Our Case Number: ABP-313892-22

Re: Bus Connects Blanchardstown to City Centre Core Bus Corridor Scheme
Blanchardstown to Dublin City Centre

Blanchardstown to City Centre Core Bus Corridor Response (Case: 313892)

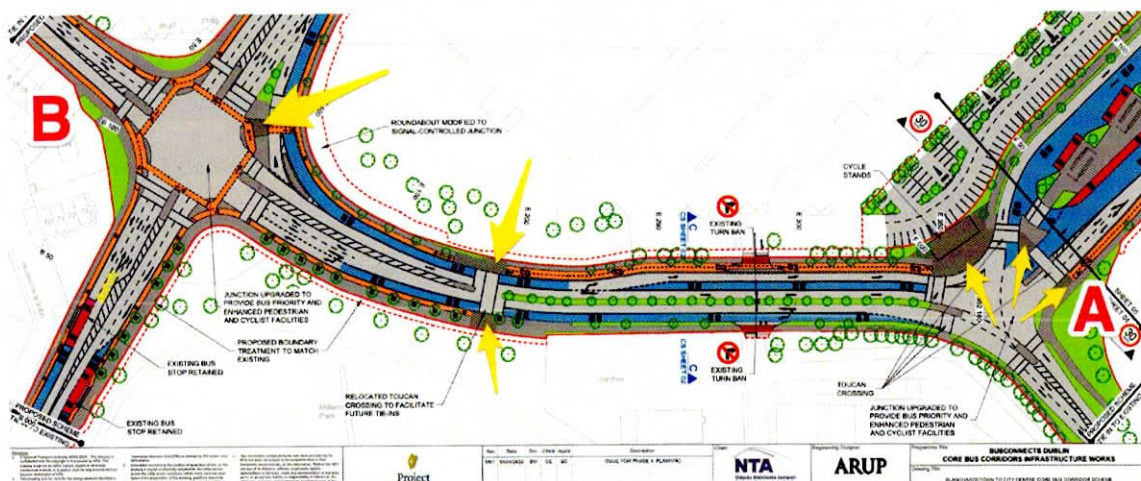
The NTA is stating that toucan crossings are level of service A. Toucan crossings are crossings shared by pedestrians and cyclists with full mixing occurring. The NTA's

manual says "shared pedestrian cyclists infrastructure should be avoided in town centres". Shared infrastructure is also a conflict described in the NTA cycle manual quality of service. This criteria that was omitted from the NTA's EIAR analysis.

The NTA is overstating the quality of the infrastructure they are delivering by not analysing the amount of shared space being forced on pedestrians and cyclists in a town centre.

Extract of sheet 04 of the General Arrangements

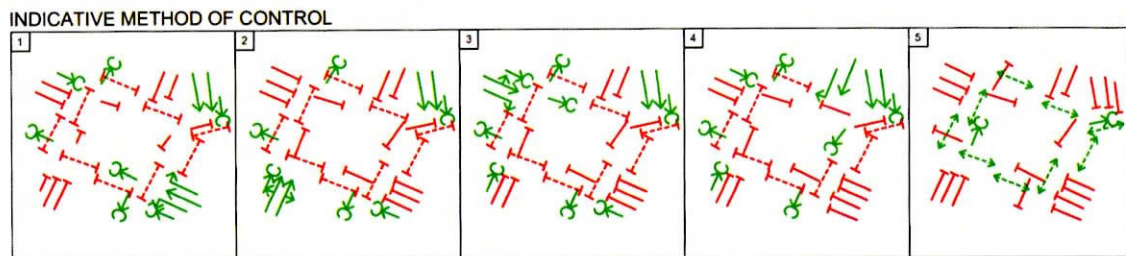
A cyclist travelling from point A to point B a distance of about 400m would travel through three shared toucan crossings, multiple shared spaces with pedestrians and pass through three junctions. The junction on the left 'Blanchardstown Road South / Blakestown Way' has a 5 phase traffic light system with cyclists able to move from Location A to B in light phase 1.

Report Appendix A6.3 Junction Design Report shows traffic light cycle time is 120 seconds for this junction. The junction design report doesn't analyze the cycle traffic delay duration. Only the delay duration for cars and buses.

The NTA has produced large junctions with long cycle times that create large delays for people walking and cycling. This directly affects the quality of service of the offered cycle route. This was ignored as a criteria by the NTA's EIAR effects analysis.

Extract of Sheet 16 General Arrangement

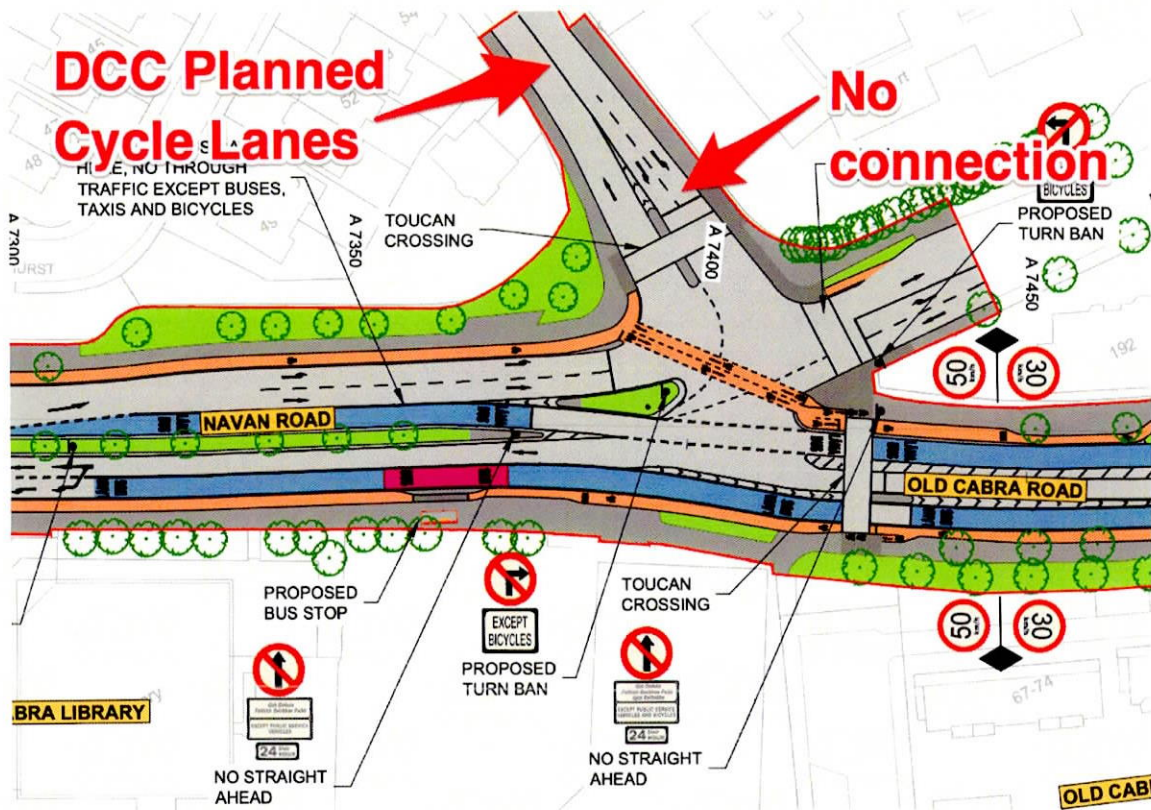
The road hasn't been actively designed to be slow and safe as required by DMURS and the National Cycle Manual.

1. The road width varies from 6m to 7.3m (cross-section N-N). DMURS says max of 5.5m and NCM states (page 54) 5.5m for 'Narrow Shared Street'
2. The road is nearly perfectly straight for 465m. DMURS recommends against long straight sections as they encourage speed. DMURS pg 114 section 4.4.7 states:

- *On longer straights where there is more than 70m between junctions. [...]*
3. There are large corner radii on Peck's Lane of 17-20m that are far above 1-3m corner radii expected on local streets. The corner radii are currently suitable for large volumes of HGVs rather than a "Quiet Cycling Street"

4. This road is the access to the community facilities of GNS Fitness/St. Brigid's GAA Club where there are 143 car parking spaces.

Castleknock Manor is fully within the red line boundary of this application. The board can, via condition, require alterations to the existing road in order to improve road safety for pedestrians and cyclists inline with DMURS.

Extract of Sheet 28 General Arrangements

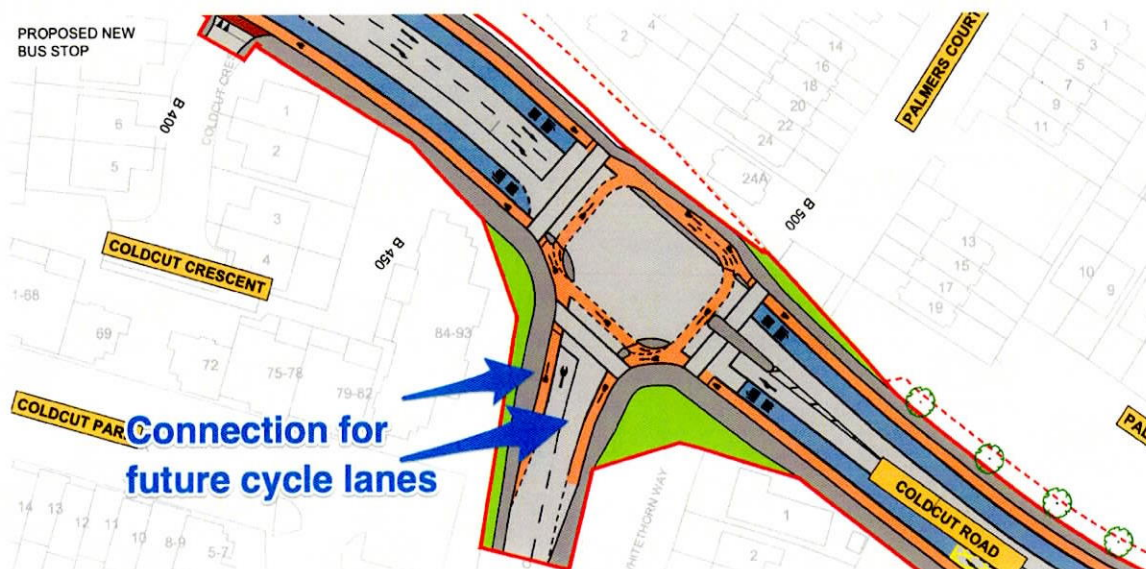
BusConnects junction design doesn't leave space for the DCC proposal to connect into this Core Bus Corridor without re-aligning the Cabra Road junction again.

The junction design proposed by the NTA for Cabra Cross doesn't take into account actively planned cycle lanes. This will leave critical gaps in the cycling network at junctions.

Our request is that the Cabra Cross junction be changed to support integration with actively planned cycle projects outside the scope of this project. The junction is within the red line boundary of this application. It is well within the power of the board to alter the design of this junction (and others) via condition.
